Model: Model HL-F1		Date: 18-Jun-10	No.: RH558001
Subject: How to access Maintenance Mode		Prepared by: Y. Gaman	
From: 2nd Overseas Tech Support Sec. 2nd PQM Dept			
Classification:	<input type="checkbox"/> Troubleshooting	<input type="checkbox"/> Part information	<input type="checkbox"/> Action required
	<input type="checkbox"/> Mechanical	<input type="checkbox"/> Electrical	<input checked="" type="checkbox"/> Service manual revision
	<input type="checkbox"/> Paper path	<input type="checkbox"/> Transmit/receive	<input type="checkbox"/> Retrofit information
	<input type="checkbox"/> Product Safety	<input type="checkbox"/> Other ()	<input checked="" type="checkbox"/> Tier 2

Model: HL-F1		Date: 5-Aug-15	No.: RH558006
Subject: Parts catalog revision - Drive Release Cam		Prepared by: Y Gaman	
From: 3rd Tech Service Sect., MFP/P Tech Service Dept.			
Classification:	<input type="checkbox"/> Troubleshooting	<input checked="" type="checkbox"/> Part information	<input type="checkbox"/> Action required
	<input type="checkbox"/> Mechanical	<input type="checkbox"/> Electrical	<input type="checkbox"/> Service manual revision
	<input type="checkbox"/> Paper path	<input type="checkbox"/> Trans

8. Drive and Frames (H558)

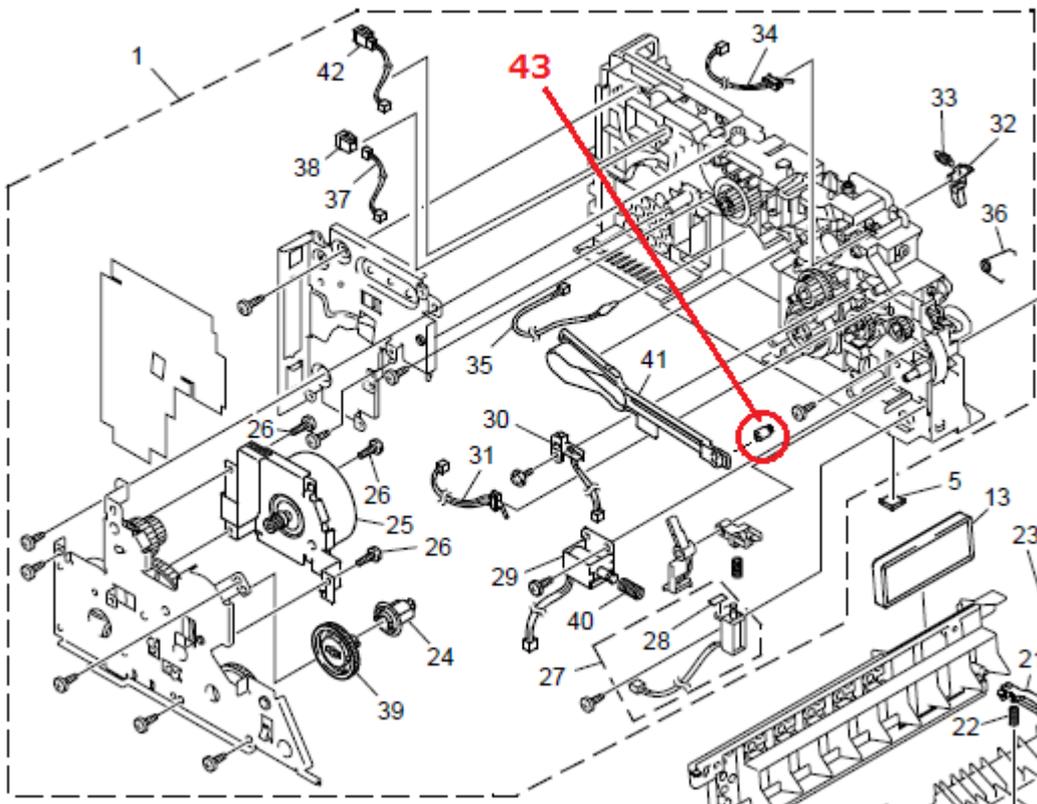
Old part number	New part number	Description	Q'ty	Int	Page	Index	Note
H5581500	H5581665	MAIN FRAME L ASS'Y: LS3996001	1	O/O	17	1	
H5581518	H5581663	DRIVE RELEASE CAM: LU1327001	1	X/O	17	41	
-	H5581664	RUBBER SPACER:LU1323001	1	X/O	17	43

Note: The cam and spacer must always be replaced as a set.

Change:

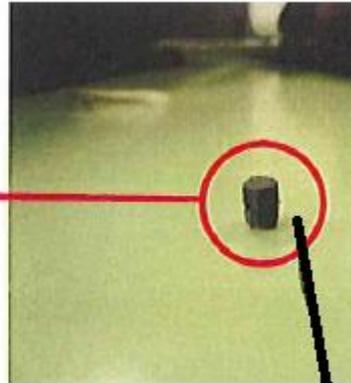
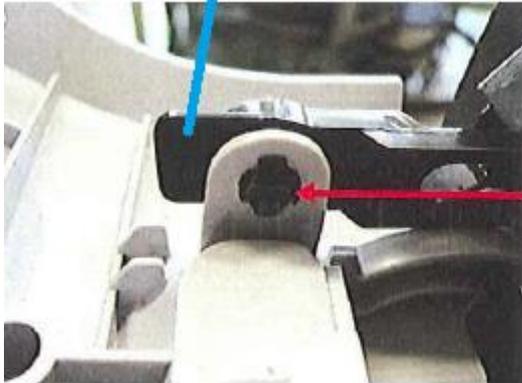
The shape of the Drive Release Cam was changed and the Rubber Spacer was added.

DRIVE RELEASE CAM**RUBBER SPACER****Reason:**

To prevent the Drive Release Cam from detaching from the front cover.
